SUBJECT: REVISED RELOAD TECHNICAL SPECIFICATIONS (TAC 00450) (TS 254)  
BROWNS FERRY NUCLEAR PLANT, UNIT 2

The Commission has issued the enclosed Amendment No. 172, to Facility Operating License No. DPR-52 for the Browns Ferry Nuclear Plant, Unit 2. This amendment is in response to your application dated August 26, 1988. This amendment updates the Unit 2 Technical Specifications to reflect revised reactor core operating limits for Cycle 6 operation.

Amendment No. 172  
License No. DPR-52

SUPPORTING AMENDMENT NO.172 TO FACILITY OPERATING LICENSE NO. DPR-52

Figure 3.5.K-1 -  
 MCPR Limits for P8 X 8R/8 X 8R/ QUAD+

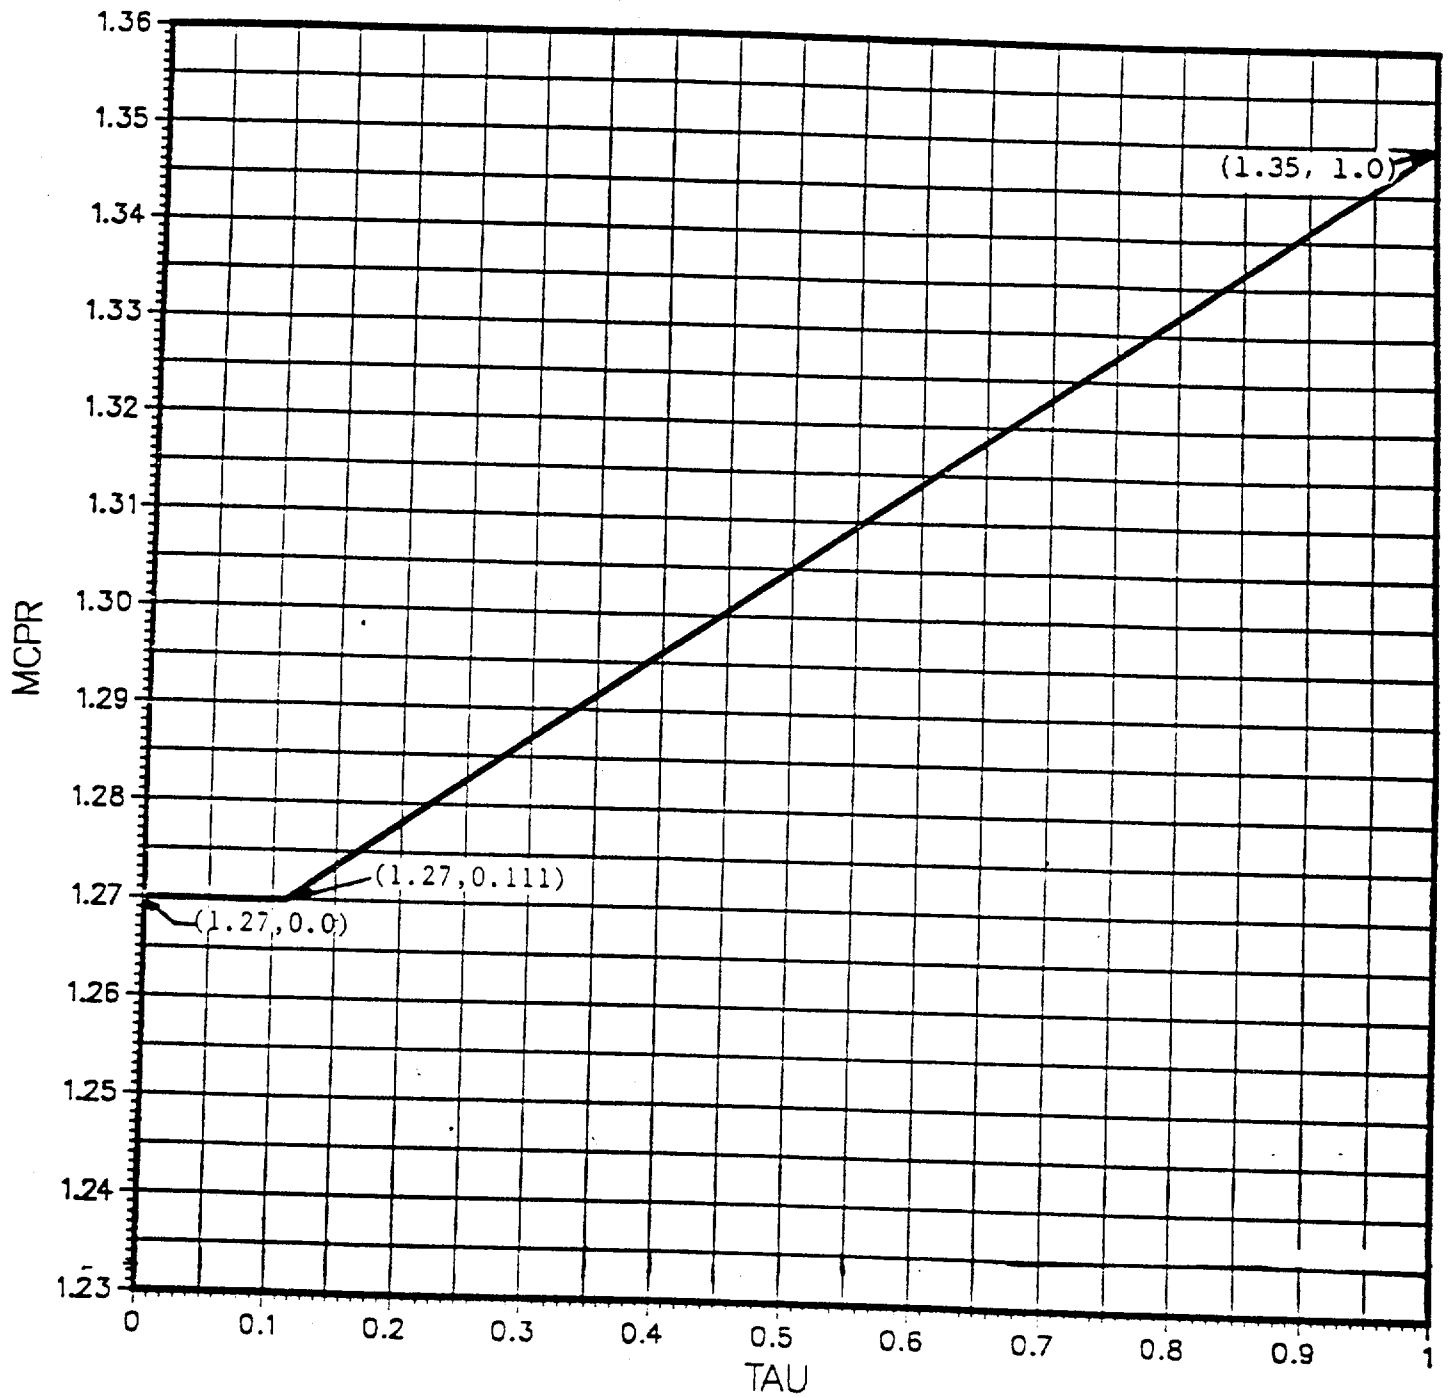
The Technical Specification (TS) changes proposed by the licensee reflect the new fuel to be loaded in the BFN Plant Unit 2 for Cycle 6 operation. These changes include core related changes for Linear Heat Generation Rate (LHGR) Limit, MCPR operating limits and MAPLHGR curves for the new fuel. Specifically, Tables 3.5.I.1 and 3.5.I.2 contained revised MAPLHGR limits based upon the licensee's acceptable reanalyses as discussed above. Tables 3.5.I-3 and 3.5.I-4 added new MAPLHGR limits for the two new fuel types resulting from the fuel reconstitution effort. Figure 3.5.K-1 provides a revised curve for calculating MCPR limits again based upon the licensee's revised analysis.

The minimum critical power ratio (MCPR) as a function of scram time and core flow, shall be equal to or greater than shown in Figure 3.5.K-1 multiplied by the  $K_F$  shown in Figure 3.5.2, where:

1. MCPR shall be determined daily during reactor power operation at  $\geq 25\%$  rated thermal power and following any change in power level or distribution that would cause operation with a limiting control rod pattern as described in the bases for Specification 3.3.
2. The MCPR limit shall be determined for each fuel type 8X8, 8X8R, P8X8R, from Figure 3.5.K-1, respectively, using:
